Re: Ecology Comments on Groundwater Monitoring Well Decommissioning Plan

- **Site Name:** Columbia Square Properties
- **Site Address:** 320 N Columbia Street, Olympia, WA 98501
- **Facility/Site No.:** 91682829
- **Cleanup Site No.:** 6851
- **VCP Project No.:** SW0984

Ecology has the following comments regarding GeoEngineers' *Groundwater Monitoring Well Decommissioning Plan*:

Existing Monitoring Well Locations to be Decommissioned	
Former Olympia MGP Site Olympia, Washington	
	Figure 1

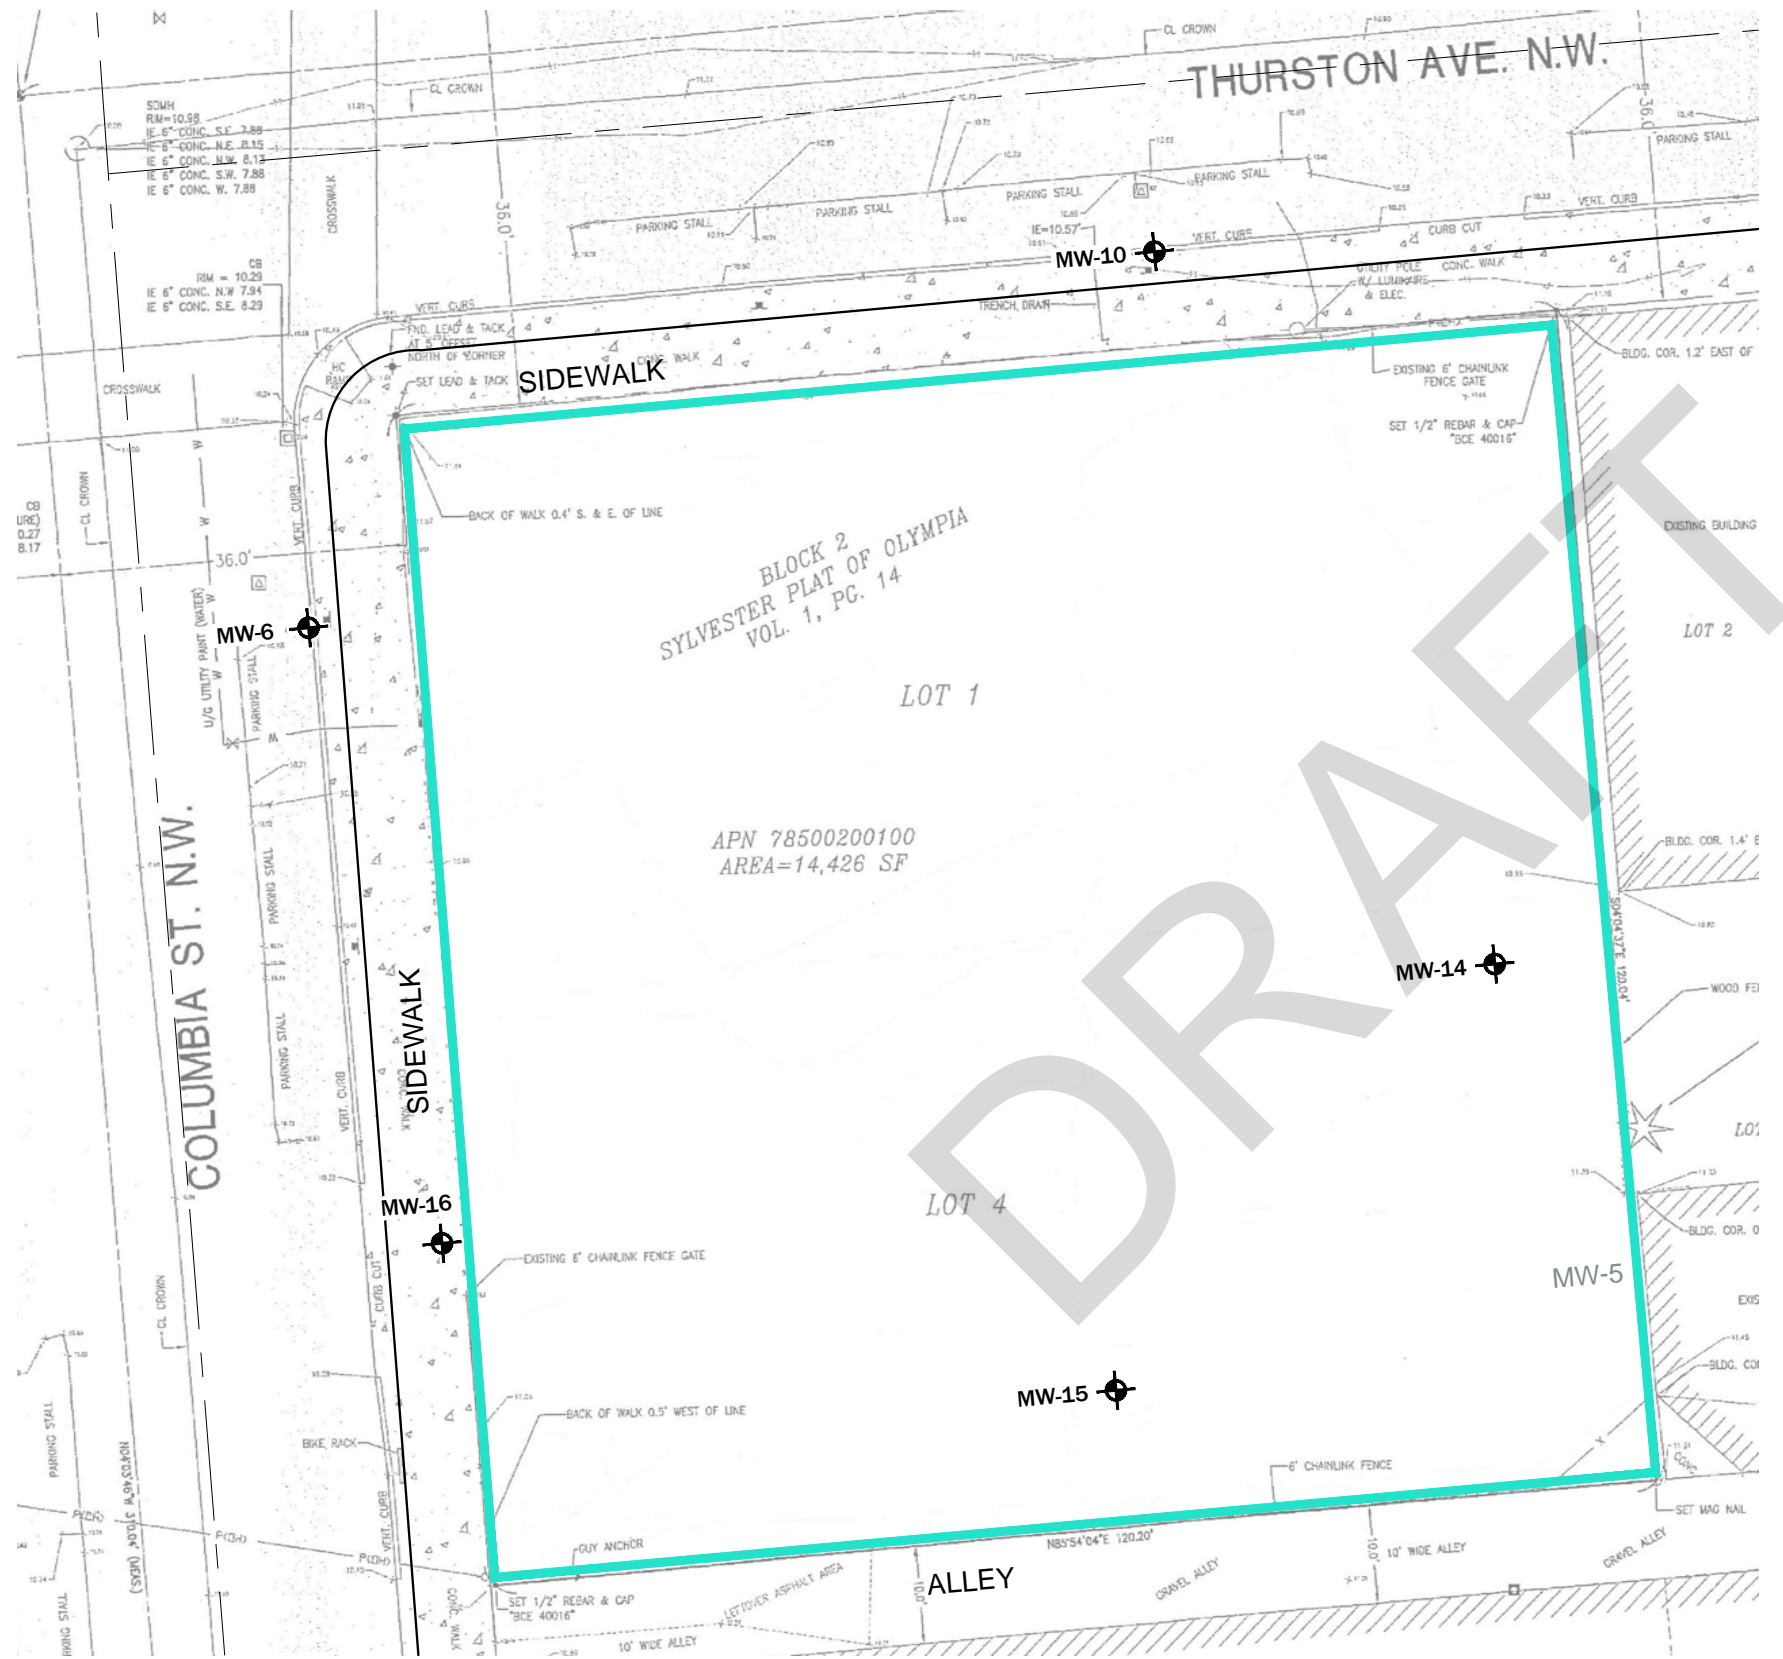
- 1) It is Ecology's opinion that the proposed well decommissioning plan can be implemented at the Site. Monitoring well locations proposed for decommissioning are shown on the enclosed figure (**Enclosure A**).

- 3) Monitoring wells MW-6 and MW-10 should be overdrilled, as no well logs are available.
 - a. If utility conflicts make overdrilling of either MW-6 or MW-10 impossible, any variance request should be directed to John Pearch of Ecology's Southwest Regional Office, Water Resources Division at (360) 407-0297 or john.pearch@ecy.wa.gov.
